ADDENDUM TO
SPECIFICATIONS ENTITLED
"Reroofing Construction Project
At USC Old Observatory Building"
DATED July 2020

ADDENDUM NO. 1

August 19, 2020

1 OLD OBSERVATORY BUILDING ROOF PLAN

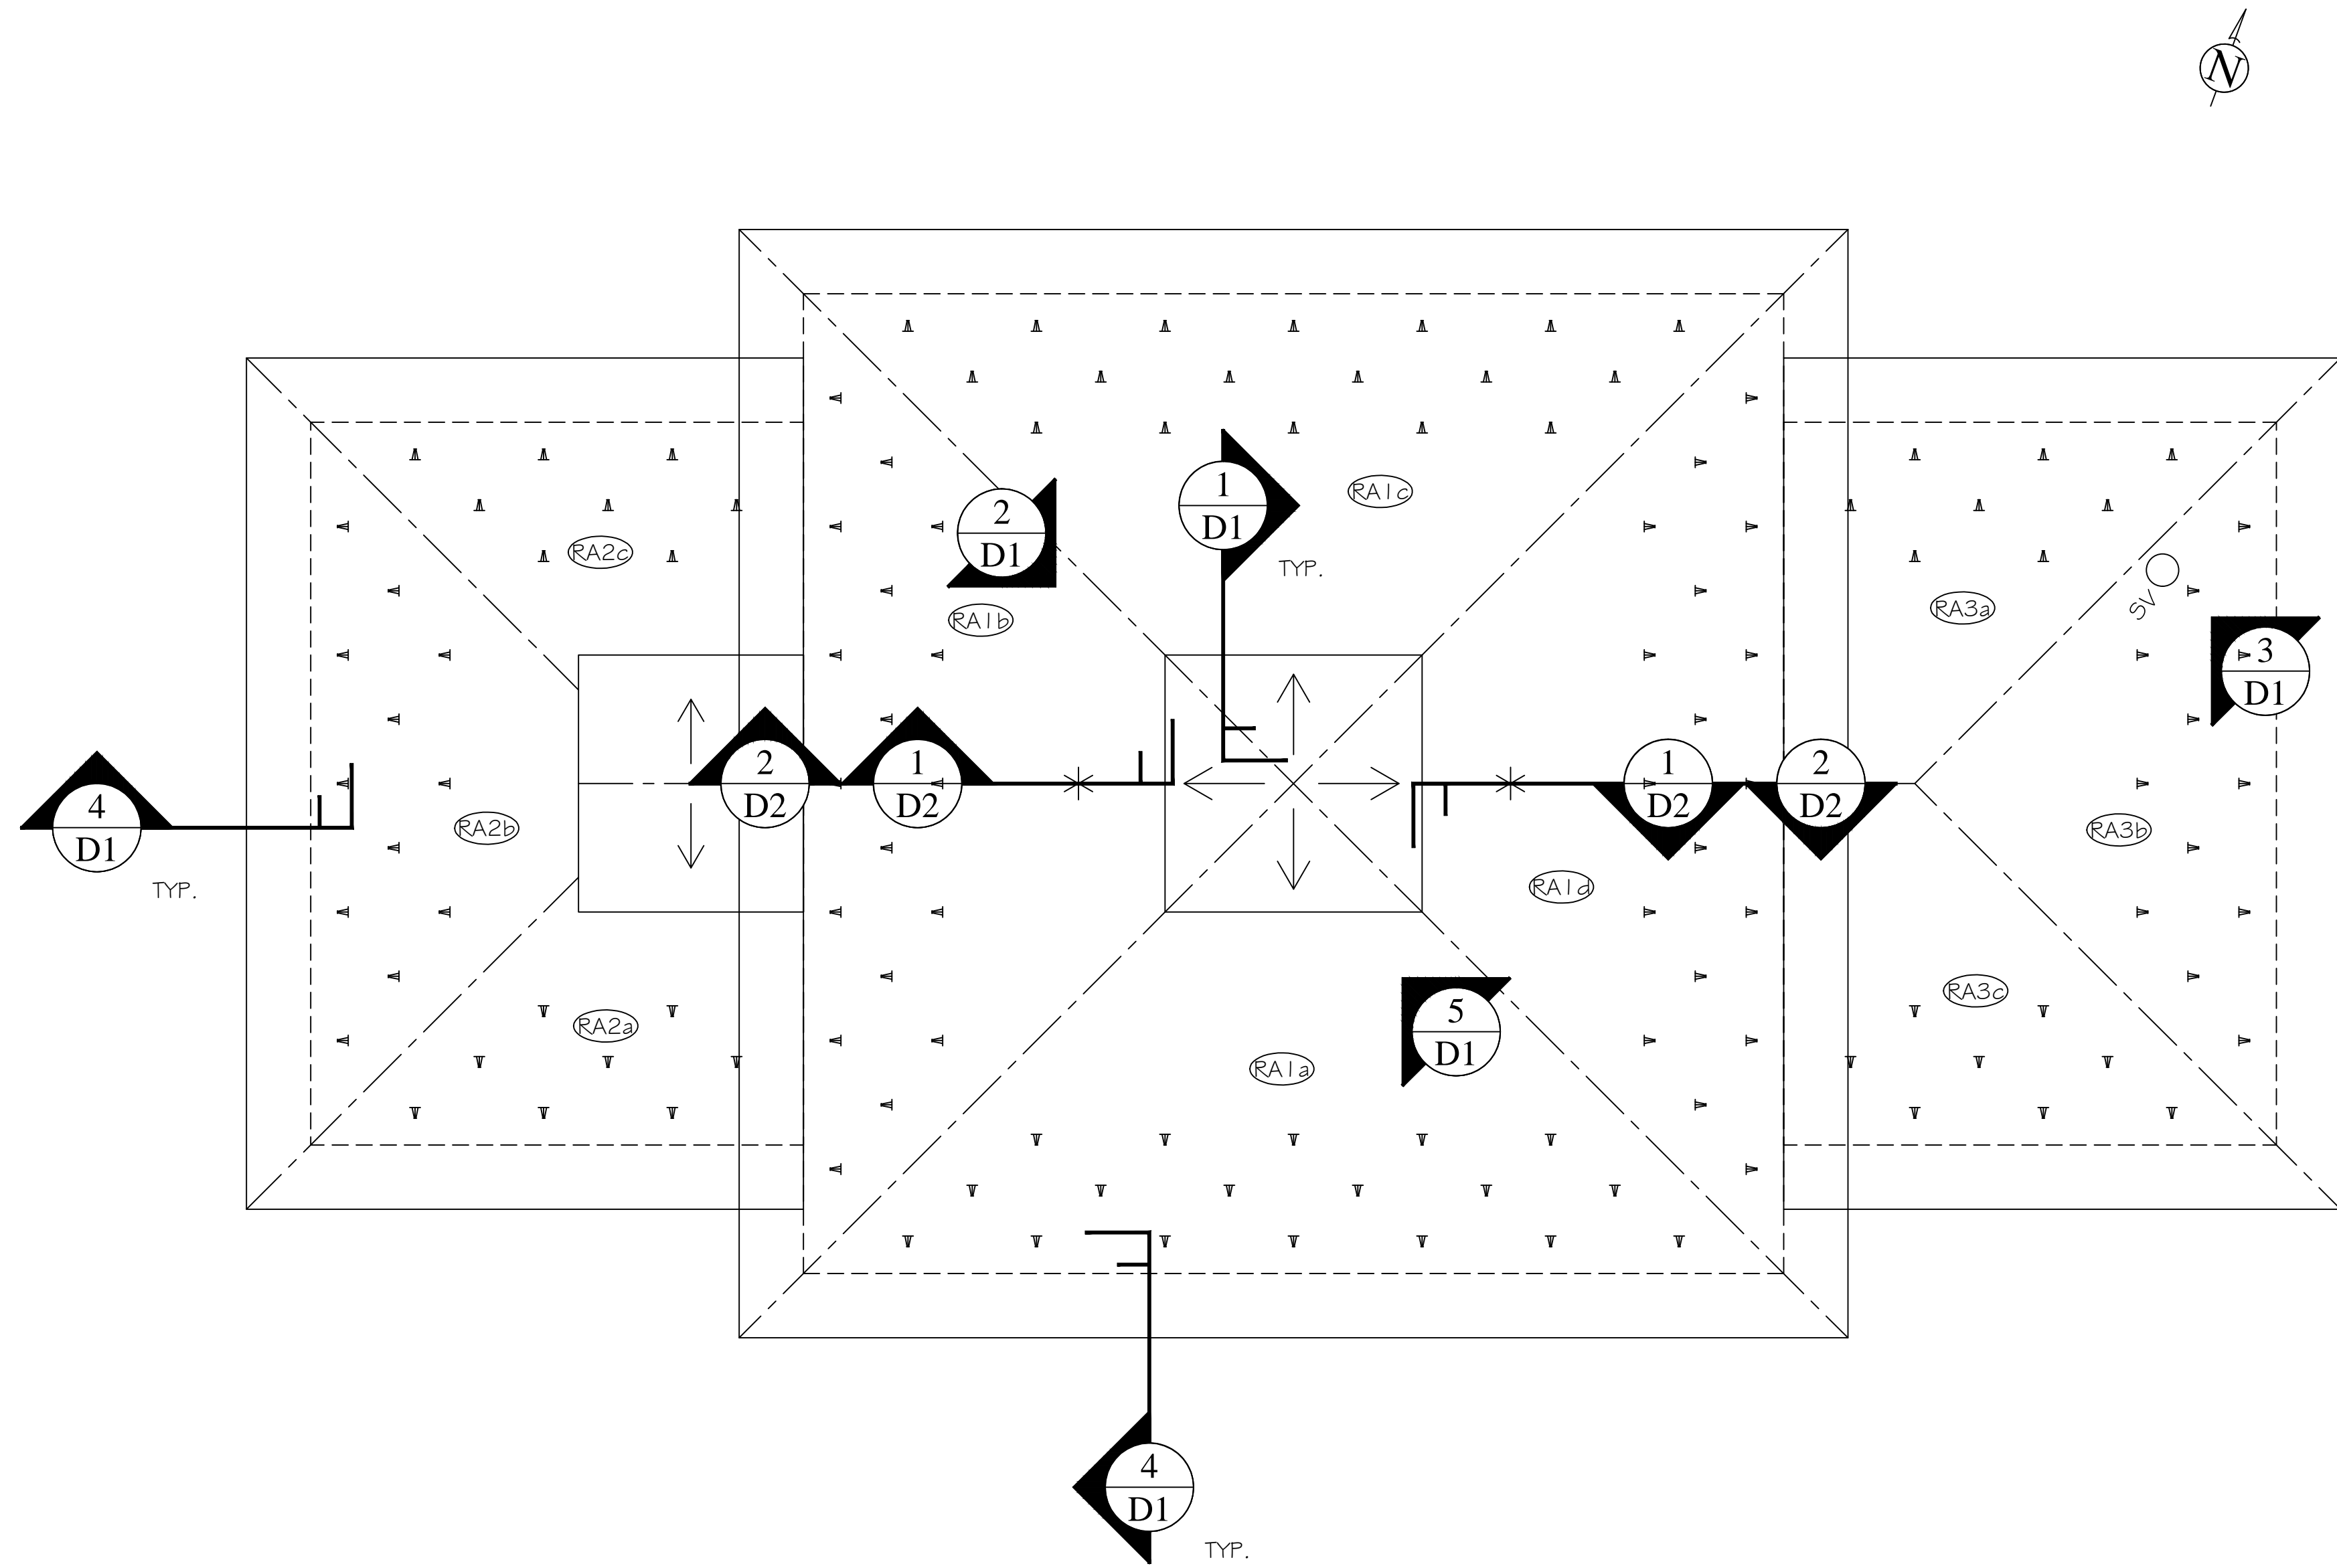
- R1 – Added snow guards to the roof plan
- D1 – Removed "Optional" sealant choice in Detail 3 - Sanitary Vent.
- K1, R1, D1 and D2 – reference to 95% Construction Documents is changed to "CONSTRUCTION DOCUMENTS".

2 ATTIC ACCESS PANEL

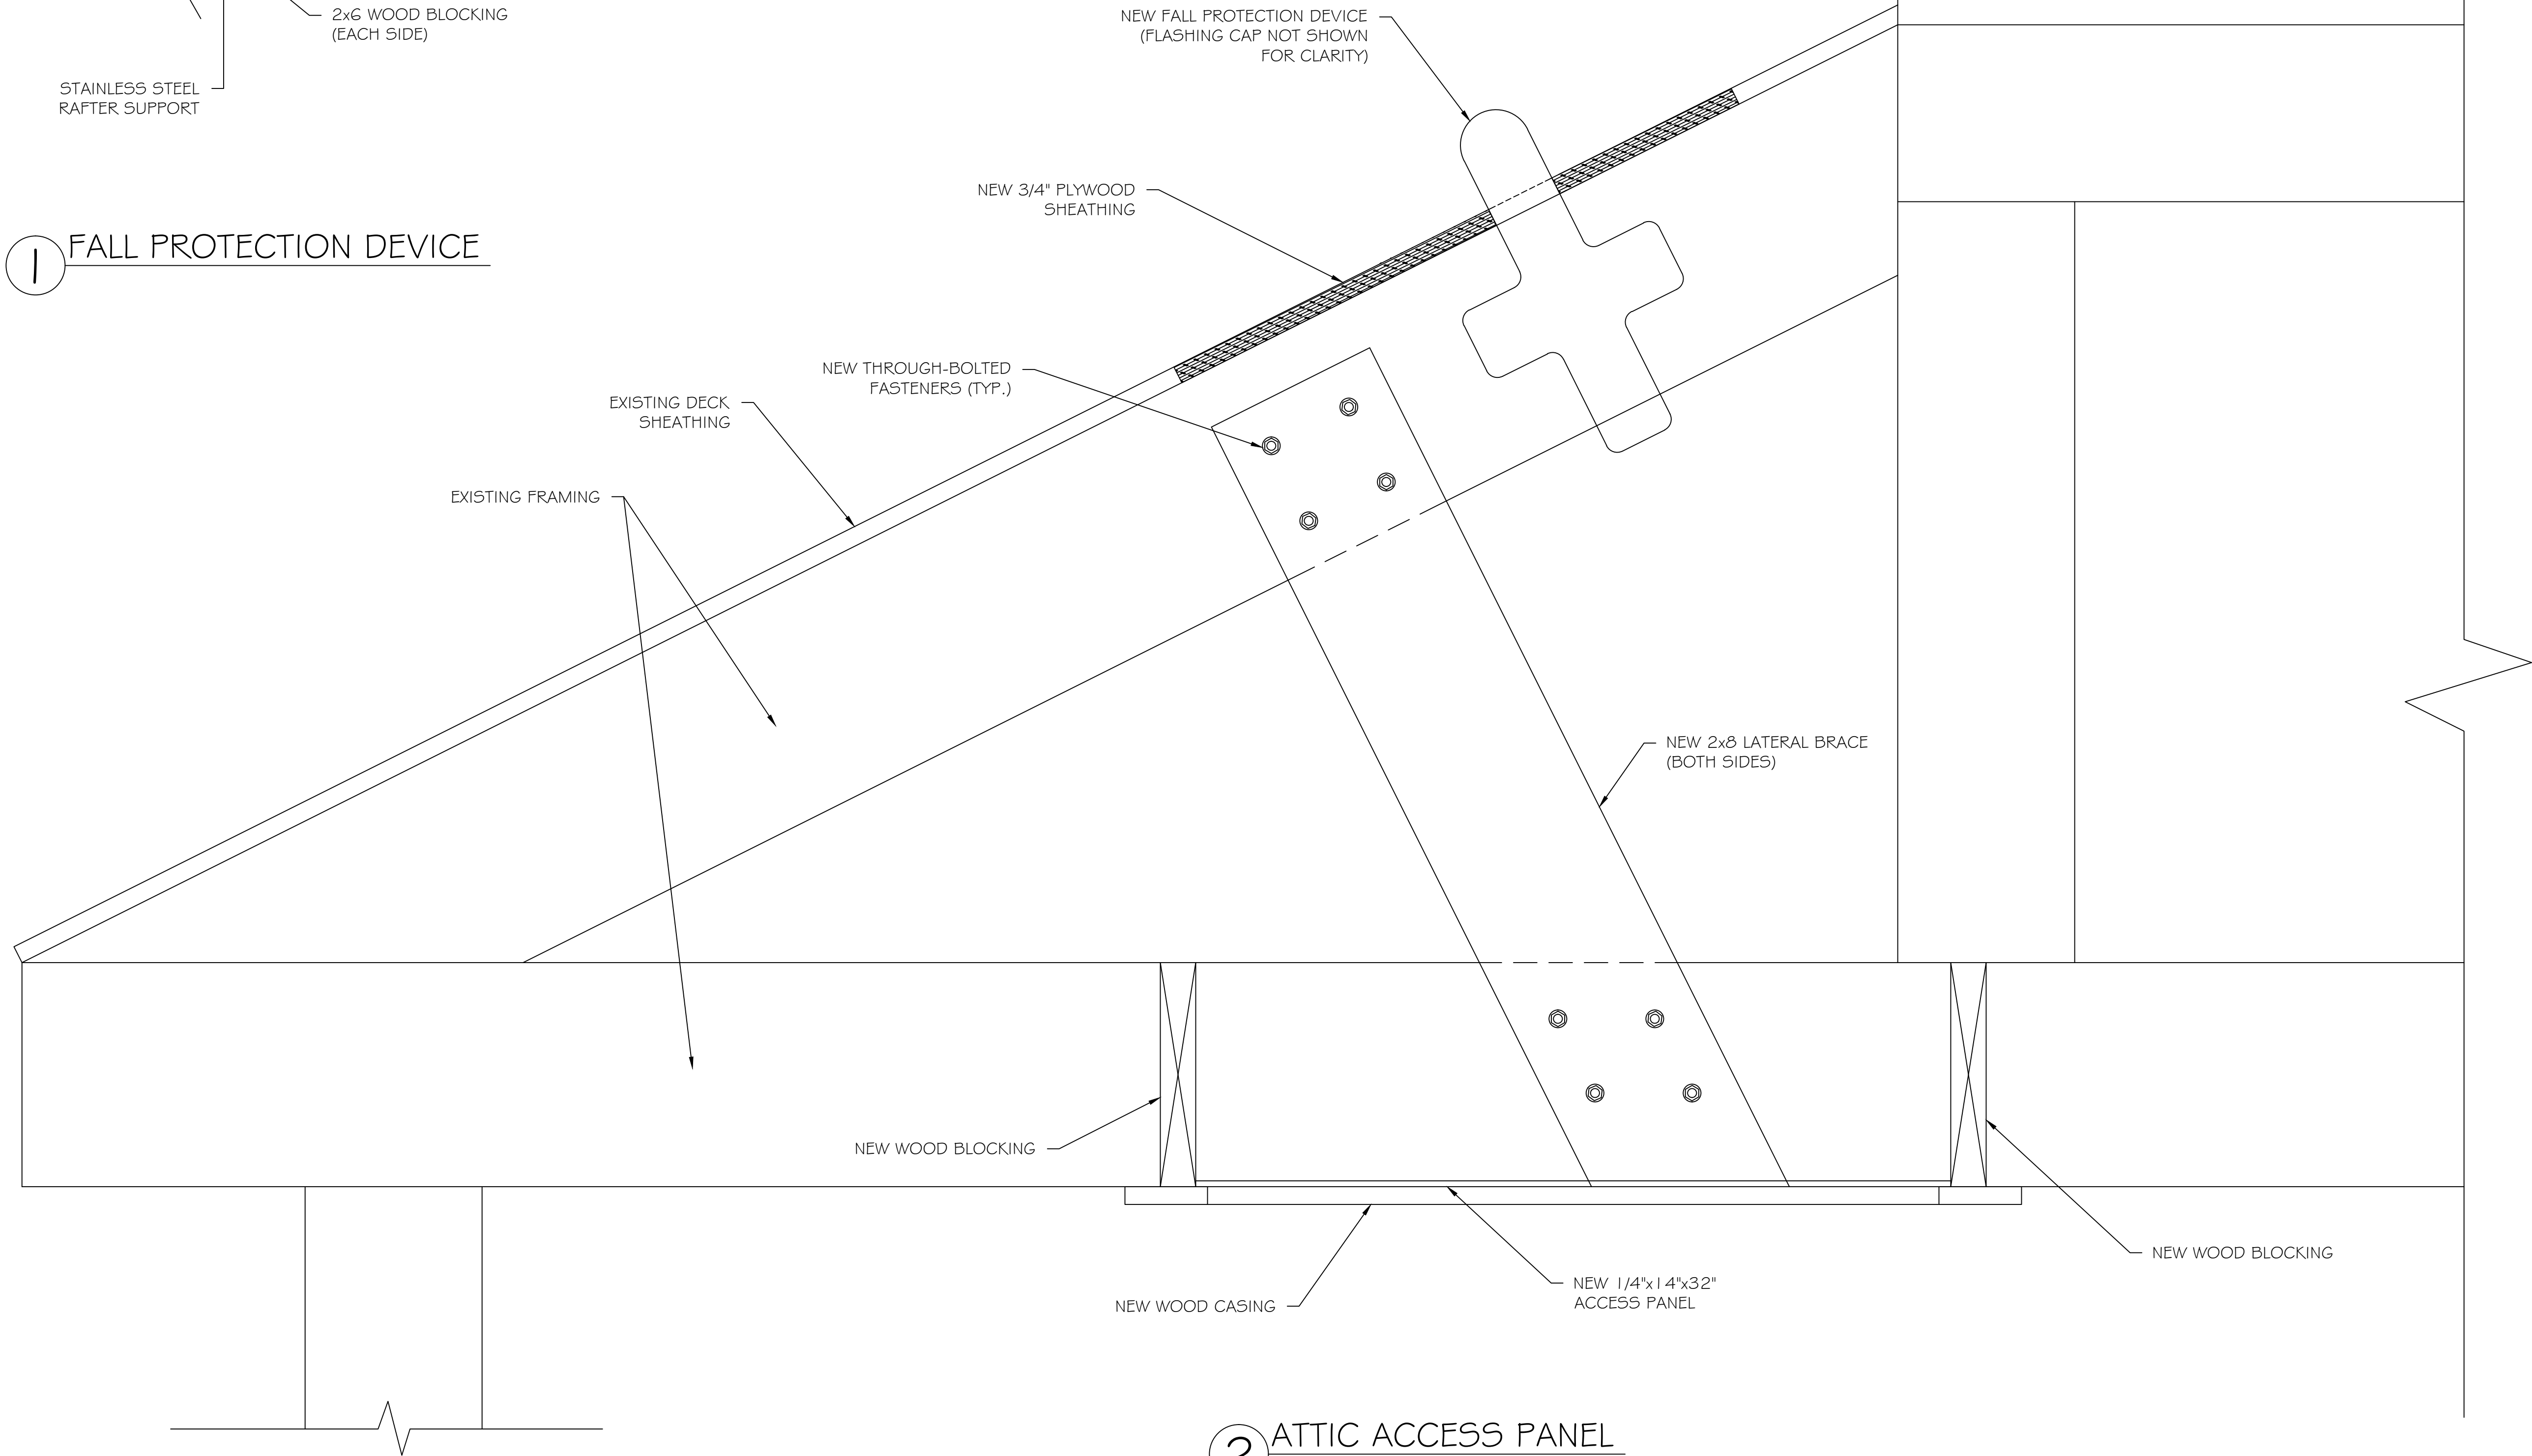
3.4.2 After the removal by OWNER of the drywall or plaster ceiling openings (approximately 14" x 32") between (2) adjacent joists. Contractor is to case the opening with 1x4 casing.
